SY171708-18_B01

Re: Macquarie Park Stage 2 – “Building E” SSDA (SSD – 63235720) – Response to Flooding Related Request for Information

Response to City of Ryde Request for Further Information

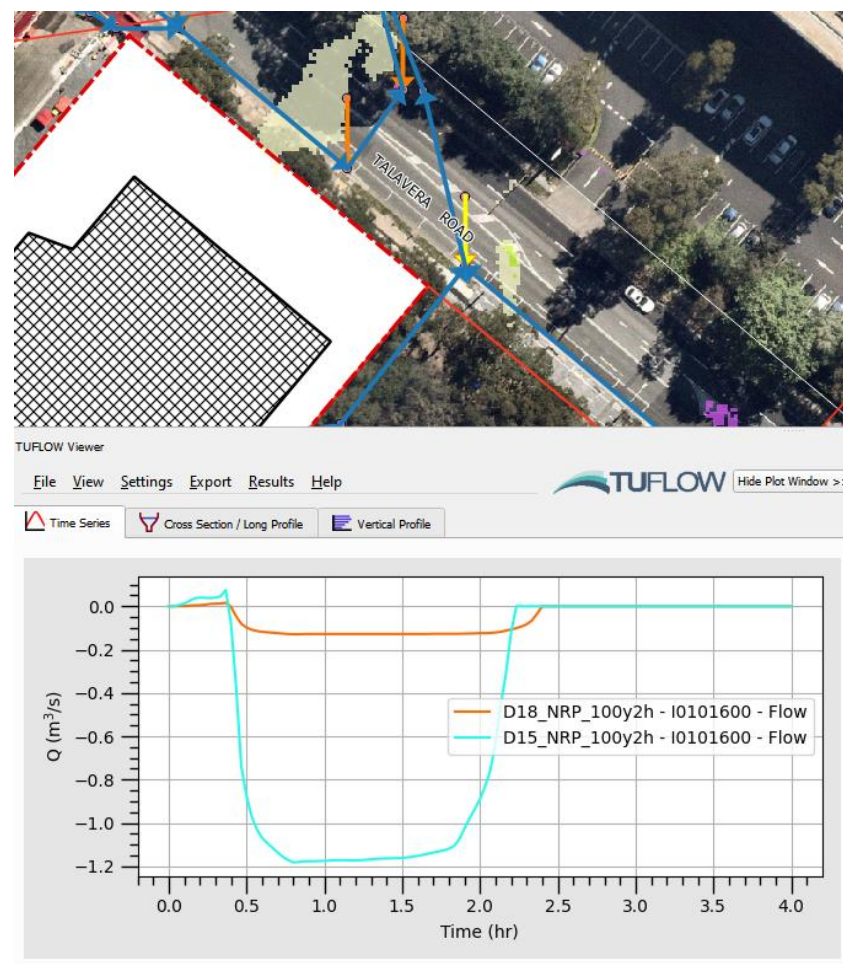
This relationship is demonstrated by the below graph which shows flows discharging from a pit in Talavera Road (i.e. the line highlighted yellow).

Note that, negative values indicate flows are upwelling and spilling onto the road carriageway, positive values would indicate flows are entering into the below ground stormwater network.

The above figure presents both model Scenarios D15, (i.e. the original model submitted to Council, and presented in the FIRA (Northrop, 2015)) and D18 (i.e. D15 with 90% blockage factor applied). The results show a significant decrease in flows exiting the pit and passing onto Talavera Road for D18 (i.e. severe blockage scenario), thus confirming the hypothesis that less upwelling occurs. This reduction in upwelling results in the minor decrease in flood levels that are observed in Talavera Road.

Figure 1
Blockage Sensitivity
Elevation Difference
1% AEP Flood Event

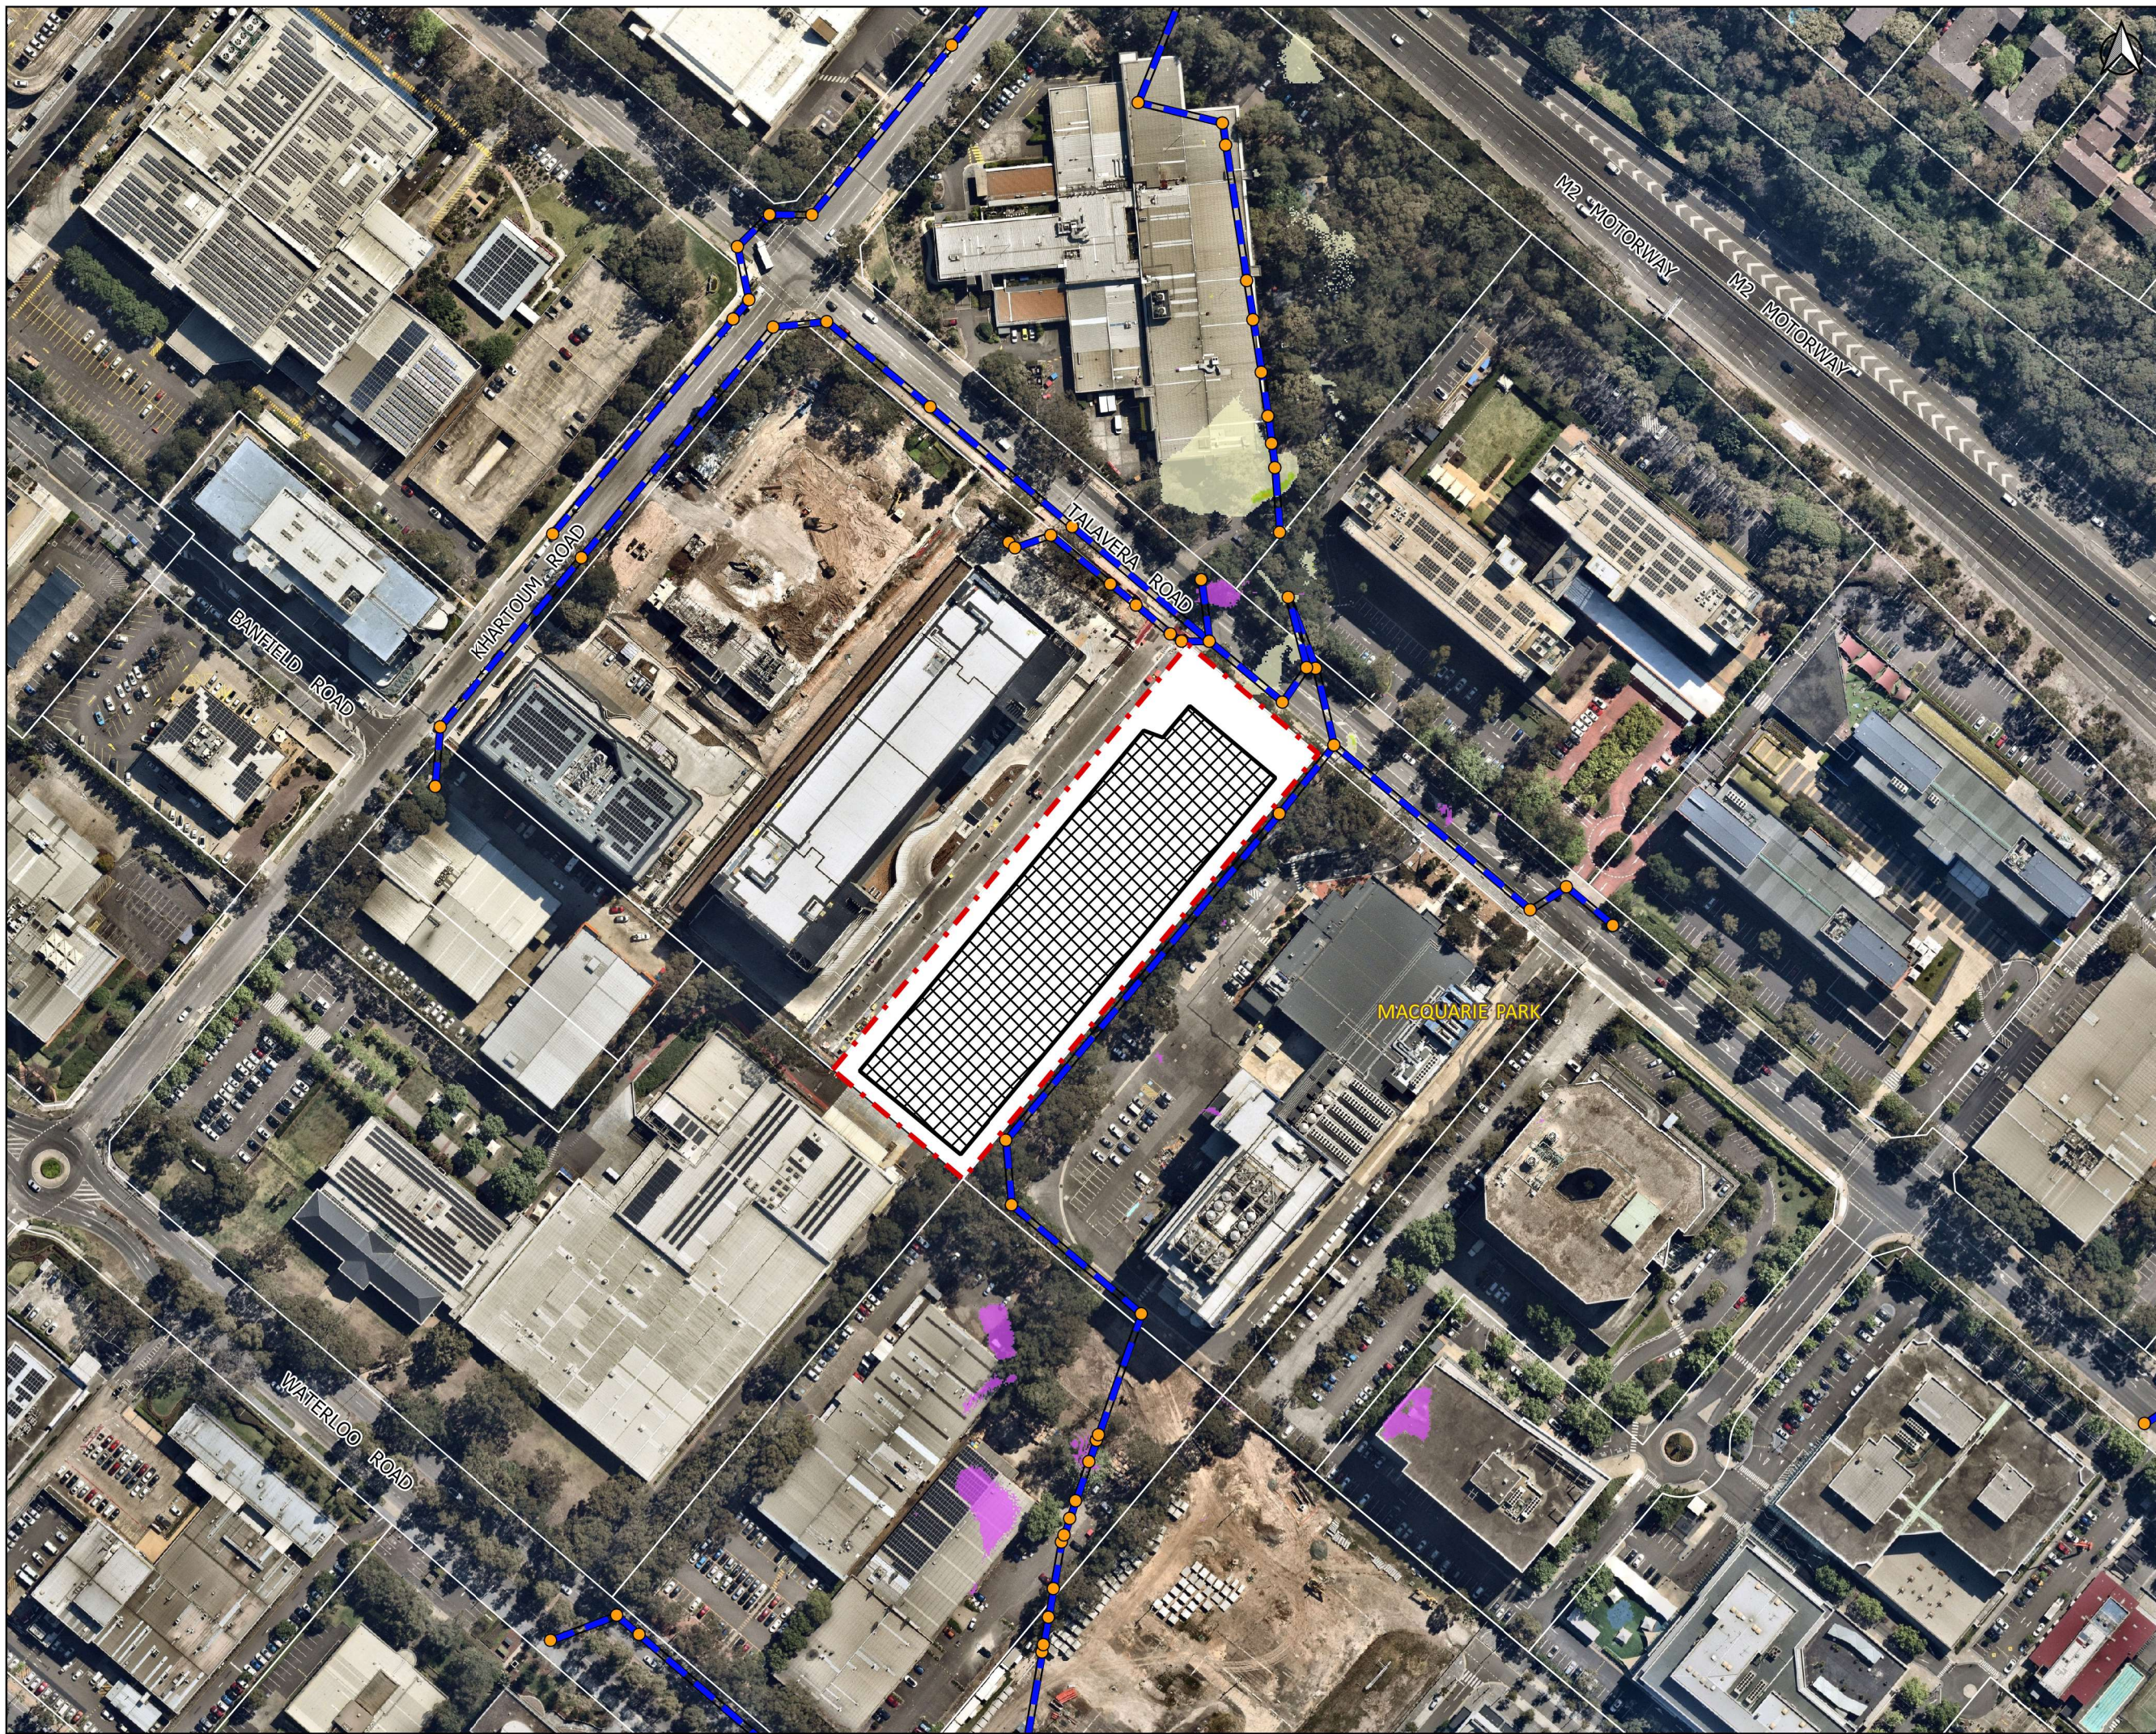
With respect to Item 2 above, a blockage sensitivity test has been performed using the modelling presented in the FIRA (Northrop, 2025).

For the purposes of the sensitivity test, the inlet blockage of the stormwater pits within Talavera Road at the site frontage, were increased to 90% to represent a severe blockage scenario. The results were then compared to the modelling that is already presented in the FIRA (Northrop, 2025). Both the 1% AEP and PMF design storm events were considered for the analysis.

The results of the sensitivity test are presented in Figures 1 and 2 of Attachment 1. During the 1% AEP, Figure 1 shows minor decreases are expected in Talavera Road, across the site frontage and downstream. Similarly, some minor increases are observed upstream of the subject site.

These changes are expected to be the result of upwelling that occurs in Talavera Road during the design blockage scenario for the 1% AEP design storm event. The increased blockage factor applied to the stormwater network in Talavera Road, reduces the quantity of flows that upwell into the street. This reduces the hydraulic capacity of the 2.1m RCP line that runs through 17-23 Talavera Road, forcing additional flows to continue overland, rather than through the pipe.

Based on the above, and the results presented in Figures 1 and 2 of Attachment 1, the flood levels in Talavera Road are not expected to be sensitive to blockage during both the 1% AEP and PMF design storm events.
